# UNITED STATES PATENT AND TRADEMARK OFFICE

APPLICATION NO.	FILING DATE	FIRST NAMED INVENTOR	ATTORNEY DOCKET NO.	CONFIRMATION NO.
10/532,800	12/27/2005	Ludwig Boge	3081.114US01	8931

## Office Action Summary

### DETAILED ACTION

FIG. 2

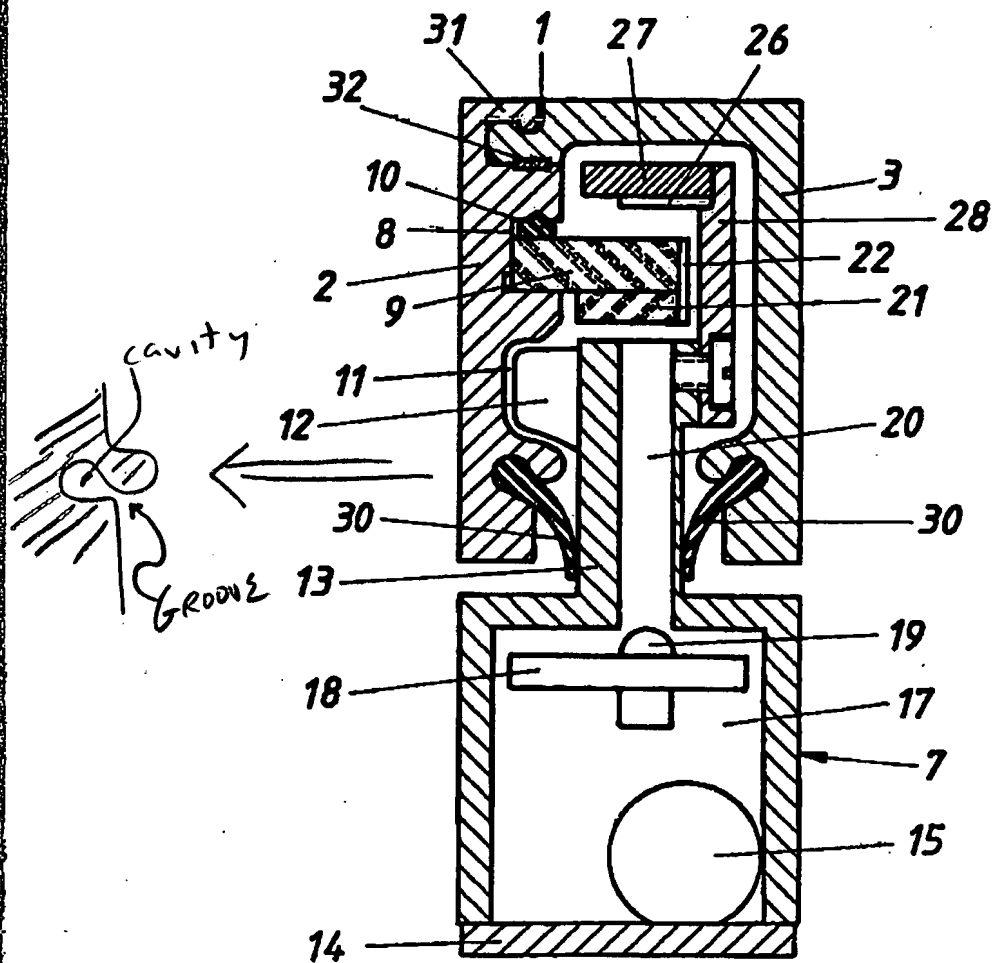
The reference teaches (Figure 2) a geometric device for distance measurement system for "machine tools" (p. 1, line 20, Translation), including: sensing head 27,28,20 and rule 21,22 sensed by it, the head being mountable on a first machine part via block 6 and the rule being mountable with a second machine part via block 4. The device includes mounting the rule within 22,21 within a profiled part 3 that has two parts and which is mountable on the second machine part via block 4, and into which the sensing head 27,28,20. In addition, the sensing head is positioned within the profiled part 3 by inserting the head through the end of part 3, necessarily requiring deflection of spacing members 30 for the sensor portion 20 to be inserted into the slot defined between the members, which insertion results in the middle portion of the members 30 being squeezed (i.e. clamped) between the sensing head and the part 3. Note that there is a

"groove" (See Exhibit "A") defined along the interior surface of the part where the member extends into the part 3.

The reference does not state that the members 30 are "removable".

As to claim 13, the members 30 are elastic, and appear to be forced into a "cavity" (See Exhibit "A") of the profile part, and to that extent the members 30 appear to be "removable" by simply pulling them out of the cavity. In the alternative, it is known to secure a flexible strip into such a cavity to provide for an effective attachment which is removable.

As to claim 14, the sensor head 27,28,20 is not contacting the profiled part 3, and thus the head protrudes from the profiled part 3 without being supported "thereon" (line 5 from bottom of Applicant's claim 14).
